# Groundwater Transfer Review Summary Form

Transfer/PA # T- 14500 (RA)

Application: T-14500

Applicant Name: De Armond Family, LLC

Well Location Map

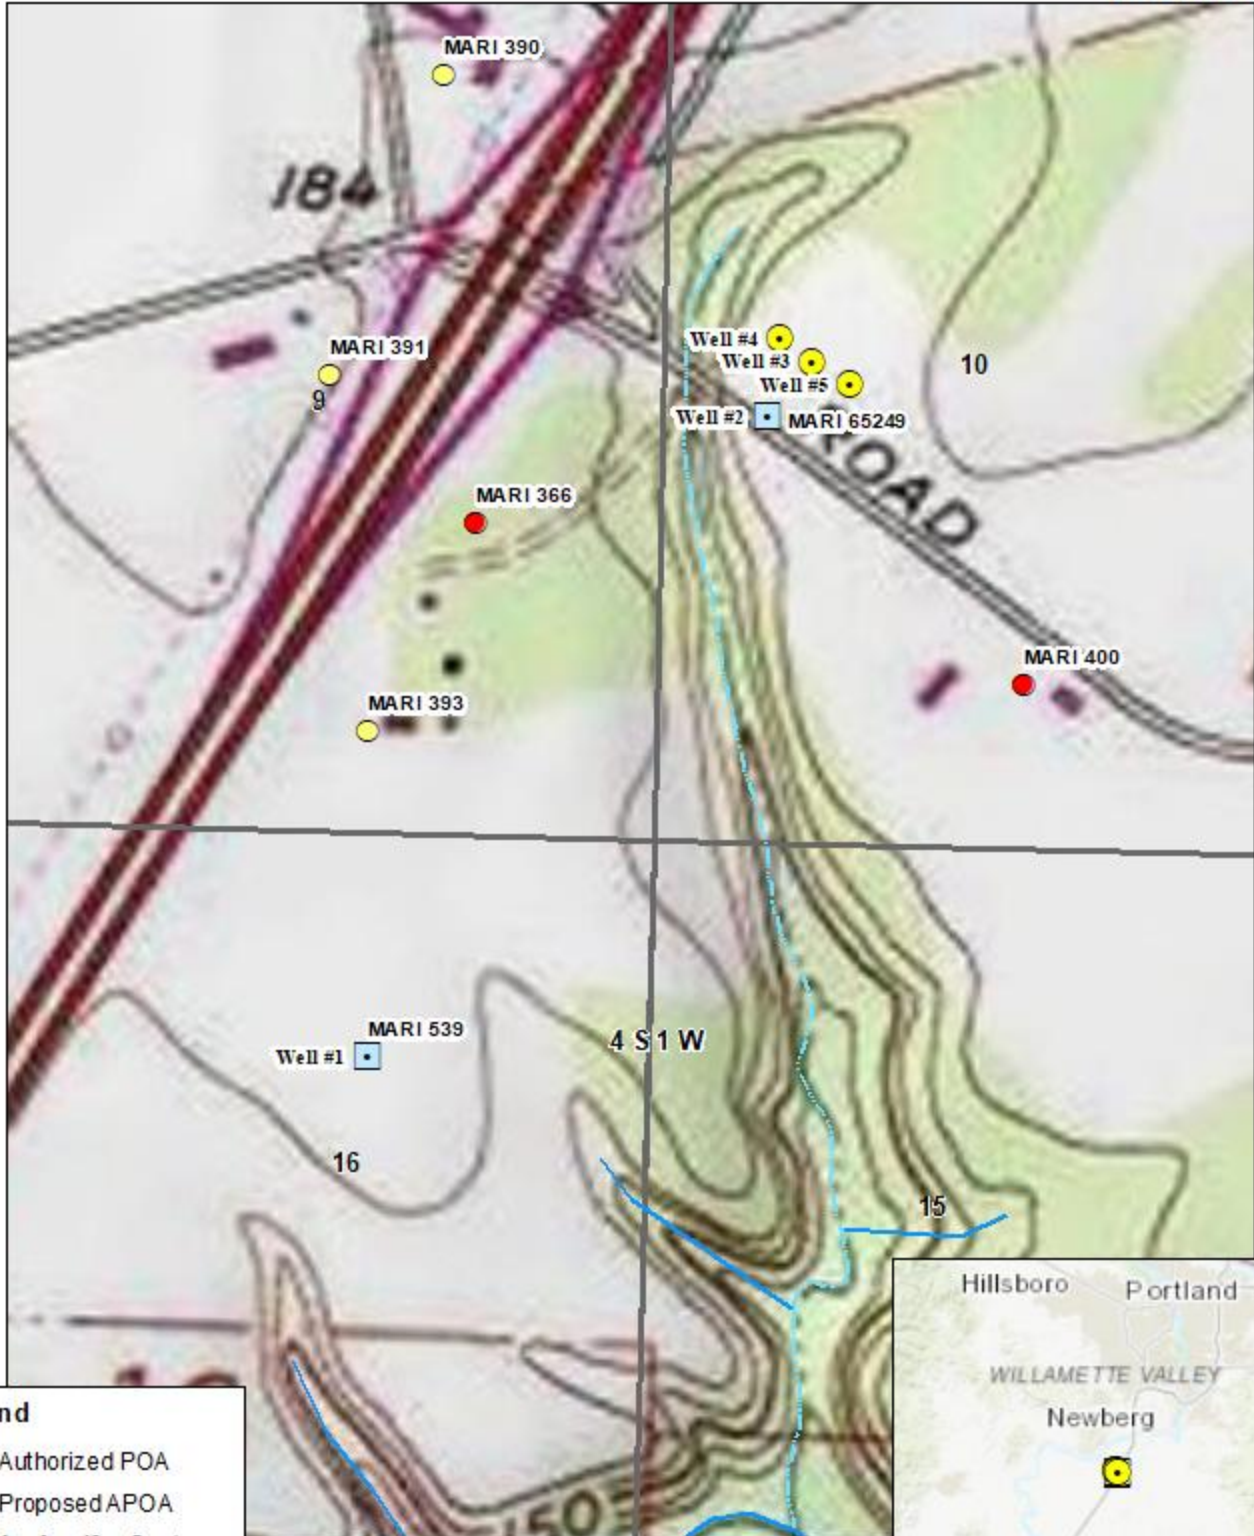
4. a) Will this proposed change, at its maximum allowed rate of use, likely result in an increase in interference with **another ground water right**?  
 Yes     No    Comments: The proposed APOA are ~200-250 ft from authorized POA “Well #2” (MARI 65249) and are not appreciably closer to neighboring alluvial water wells. No increase in interference with neighboring water wells is anticipated.

Yes  No Comments: The proposed APOA are ~200-250 ft from authorized POA "Well #2" (MARI 65249) and are not appreciably closer to nearby surface water sources. No increase in interference with surface water is anticipated.
